# SERVICE BULLETIN

SB No. 83 Issue No. 2

**TITLE** INSPECTION FOR FOUL BETWEEN NO.2 RUDDER PEDAL PAD PIVOT AND NOSEWHEEL STEERING ROD ARM

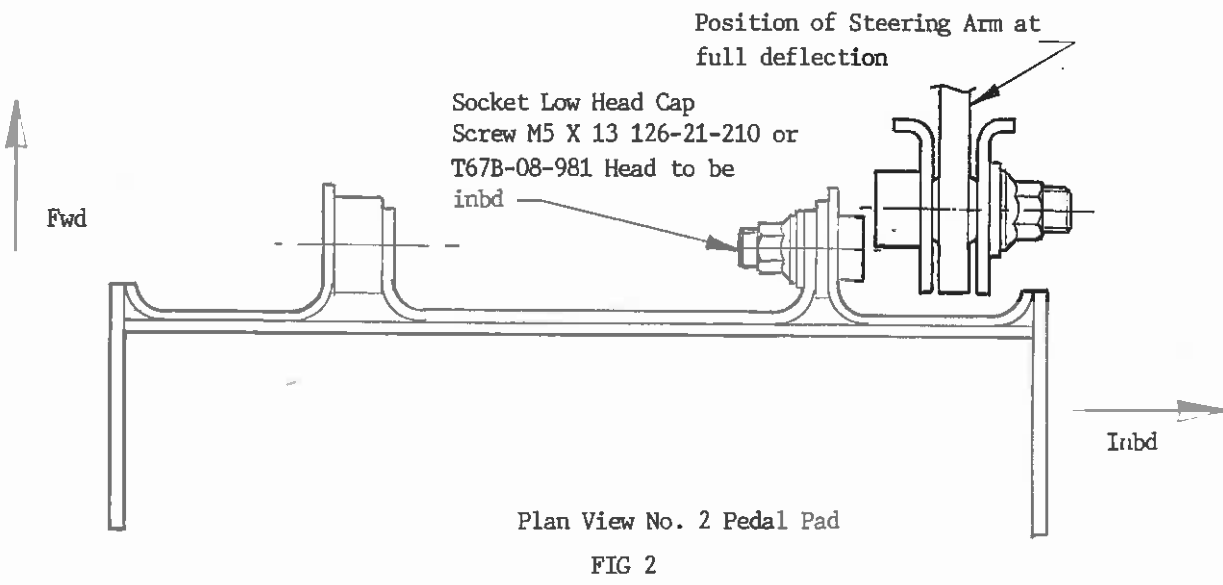
1. At Position 'A', check that bolt at nosewheel steering rod.arm attachment measured 20mm long measured from under head. If not replace with M6 x 20 126-21-050, Ref Fig. 1, orientated as shown.
2. At Position 'B', with No.2 pedal fully adjusted forward and with full right rudder check for clearance between bolt tail and bolt head Ref Fig. 1.

3. If 1mm or more clearance is shown with pedal mechanism on its stop together with correct rudder deflection with all backlash taken up to minimise the clearance, annotate in Log Book "SB 83 carried out".
4. If clearance is less than 1mm, or touching:
  - i) Replace existing socket head cap screw indicated on Fig. 1. With socket head cap screw 126-21-210 (or T67B-08-981) as shown in Fig. 2. Ensure correct rudder operation and deflections.

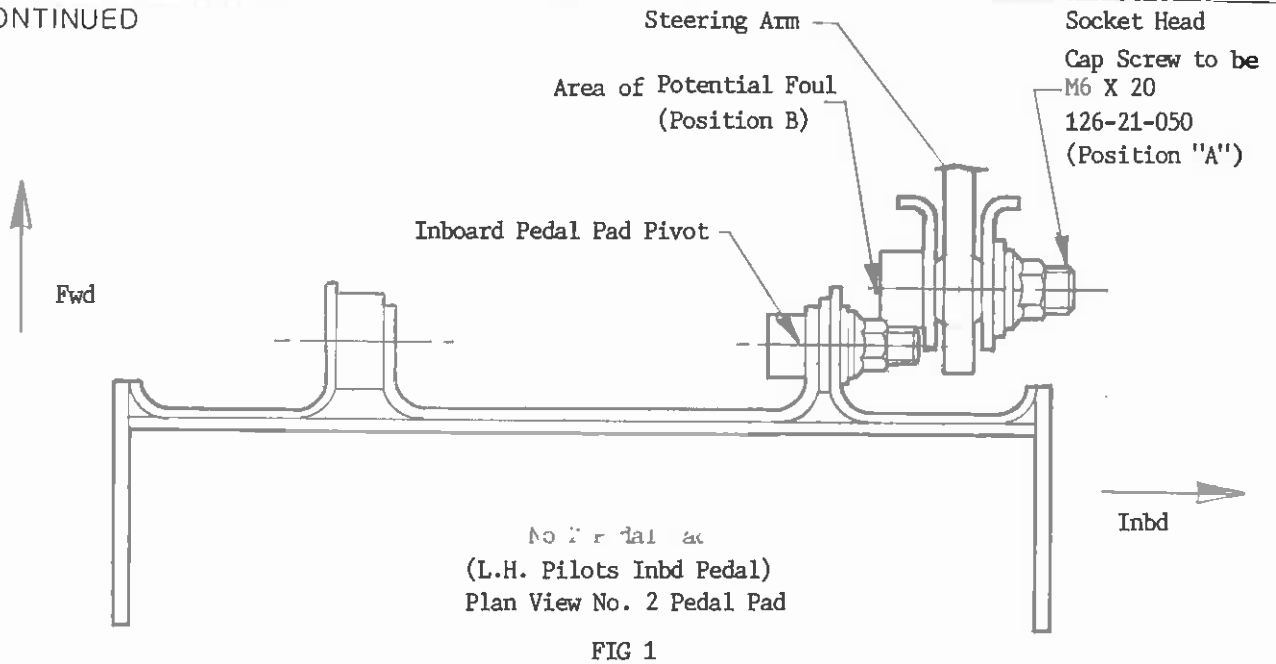
The fitting of socket head cap screw 126-21-210 (or T67B-08-981) invokes Mod M671.
  - ii) Annotate aircraft log book "SB 83 carried out" and "Mod M671 incorporated".
5. At each rudder pedal dis-assembly/re-assembly and re-rig, ensure conditions at 2. are met, until Mod M671 at 4 i) is incorporated.
